Exhibit 1.2

Milburnie Road Matrix of Required Retrofits to Public and Common Use Areas.

MILBURNIE ROAD APARTMENTS: PUBLIC AND COMMON USE AREAS

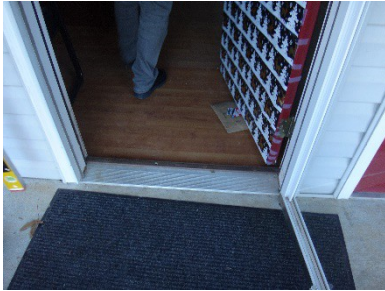
Numbers	Photos	Deficiency	Required Retrofit
	Inaccessible Slopes at Routes		
2	 <p><i>Measuring cross slope at turn to mail area.</i></p>	<p>Cross slopes of the routes/sidewalks are more than 2% (maximum 2% allowed).</p> <p>Location</p> <p>Southeast of Building 4 7.2% (at curb ramp at Gibney Dr.)</p> <p>East of Building 4 4.0% (at intersection of Gibney & Sawpit)</p> <p>East of Building 4 3.9% (route to leasing office)</p> <p>East of Building 4 4.5% (route to leasing office)</p>	Modify 3.9%, 4.0%, 4.5%, and 7.2% cross slopes to comply with ANSI 4.3.7.

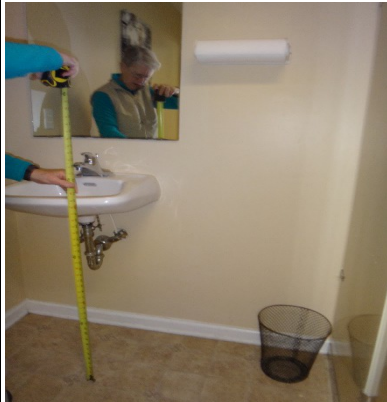
Numbers	Photos	Deficiency	Required Retrofit								
20	<p>Outlet at kitchenette countertop adjacent to refrigerator -- Photo 1.</p> <p>Clear width at countertop -- Photo 2.</p>  	<p>The countertop outlets do not have the minimum clear floor space required. Refrigerator, range, and countertop block parallel approach. The clear spaces on both sides are less than 48 inches wide (minimum 48 inches required for parallel approach. Note: maximum depth of side reach range is 25-1/2 inches.)</p>

Location	Width (inches)	Left of refrigerator	30-3/8	Between refrigerator and range	29-7/8	Between range and sink	11	Install waterproof powerstrip within reach range requirements.
Location	Width (inches)										
Left of refrigerator	30-3/8										
Between refrigerator and range	29-7/8										
Between range and sink	11
